SAVANNAH HISTORIC DISTRICT
BOARD OF REVIEW

REQUEST FOR CERTIFICATE OF APPROPRIATENESS

MPC File No.: 25-005674-COA

Address: 402 E Broughton Street

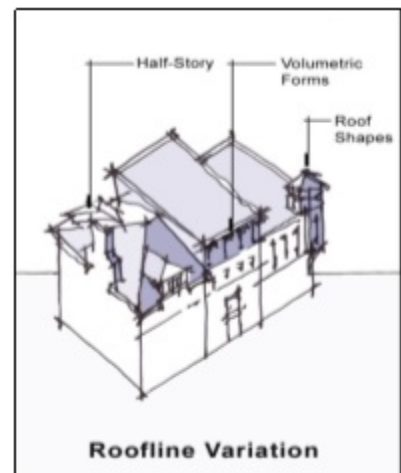
The applicant has a fourth story penthouse which is setback from the front façade. The penthouse has limited visibility and per the figure to the right, the roofline variation should be visible along the street frontage. This standard is not met.

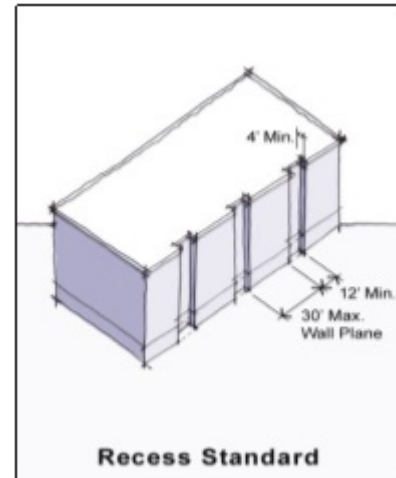
The proposed building was designed with a length of 120'4" along Broughton Street and 91'3" along Habersham Street. There are multiple columns that stand proud of the wall plane with a width of 3'. In between the columns are large, recessed areas ranging from 8'6" to 18'. The depth of each recess appears to be approximately 3' to 8'+. The third floor has several floor recesses ranging from 3' to 9' to 12'. This standard is met.
